Staff Report & Recommendations

Stephens Hillside Estates Subdivision: Type III

Preliminary Plat and SEPA DNS

(2018-016-SUB) September 11, 2018

Figure 3 Proposed Preliminary Plat

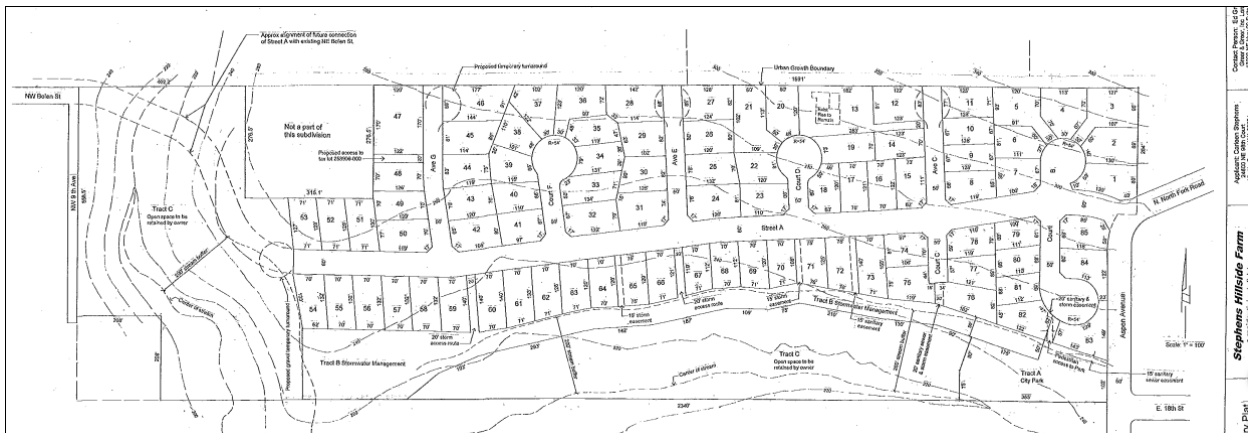
The Applicant must verify that the site distance from Court “B” will meet the Engineering Standards for site distance to North Fork Road. The minimum line of site per the Engineering Standards is 250 lineal feet at 25 MPH. The intersection spacing between Court “B” and Aspen Avenue is less than 200 feet from the centerline of the intersections. Traffic turning east onto Street “A”, from the north or south side of Court “B”, does not have adequate line of site for traffic turning right onto Street “A” from North Fork Avenue. North Fork Avenue traffic turning right onto Street “A” will not have enough line of site of traffic queuing on Court “B”. The recent update to the CFP recommends 275 feet intersection spacing for Major Collectors. The applicant will need to modify the spacing of Court “B” to provide adequate line of site to meet the city standards.

Tax lot 258962000 has a 20-foot wide ingress, egress and utility easement on the applicant's property from 348th Street. The preliminary plat submitted by the applicant does not show this easement being maintained and does not provide access to this parcel. The applicant will need to provide at least a 20-foot ingress, egress and utility easement on the plat to tax lot 258962000.

3. The development shall reconfigure the site plan to remove cul-de-sac street connections north of the "Street A" Major Collector to meet access spacing standards and preserve capacity. A Major Collector requires 275-feet between public streets.

4. The development shall reconfigure the site plan to remove or relocate the "Court B" intersection with "Street A" to meeting spacing standards. A Major Collector requires 275-feet between public streets.

Figure 4 Proposed Park Plan

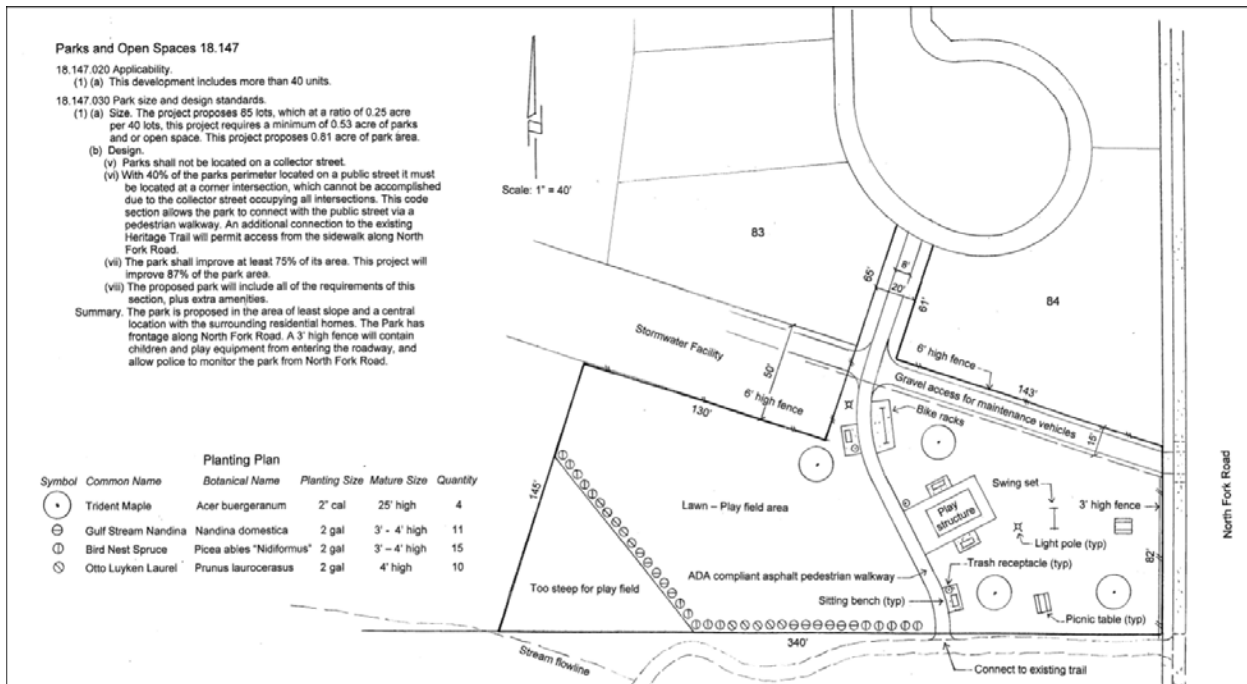
The Applicant states that the proposed park location was selected because it is the least sloped area on site and it is centrally located. The Applicant also states that *“In order to meet ADA standards, the park must be located on the least steep area of the site, which is the location proposed.”* Because of the topographic conditions, the Applicant proposes to situate the park within the stream buffer rather than on buildable land. (See LCMC 18.300.050(4)(b).

The proposed park has frontage on Aspen/North Fork. The park may be accessed from S. “B” Court Cul-de-sac via a 20 foot wide accessway to the stormwater facility and 8-foot wide pedestrian walkway to the park in Tract A. The path will connect to the existing trail south of the site. Proposed amenities include a bike rack, swing set, play structure, picnic table, sitting bench, landscaping, and lawn for play field. The southwest portion of the park is labeled *“too steep for play field”*.

The Parks Plan provides that “Family Parks”² shall be from one to five (1-5) acres in size. An 85 unit single family subdivision is only required to provide 0.53 acres of park area. The Applicant states Tract A will provide 1.06 acres of park area. The preliminary park plan states that the path will be ADA compliant but does not indicate whether other park features will be ADA compliant.

The Applicant’s argument that site topography prevents locating the park anywhere else but in the flatter riparian buffer is not supported by conclusions not substantial evidence. The Applicant proposes to grade the upland portions of the site to create building pads and could surely grade an upland portion of the site to create an ADA compliant park area. Similarly, locating a park on graded land near the northern extension of one of the cul-de-sacs could eliminate the problem of locating a park along a collector street.

As a **Condition of Approval**, prior to final Plat approval the Developer shall provide the City with a Final park plan that demonstrates how the park will comply with applicable the design requirements of chapter 18.147, Family Parks, and applicable ADA requirements.

- b. Prior to final plat approval for the first phase of development the Developer shall:
 - i. Provide the Public Works Department with a final park plan that demonstrates how the Tract A and trail park will comply with applicable the design requirements of chapter 18.147.030, Family Parks, and applicable ADA requirements.
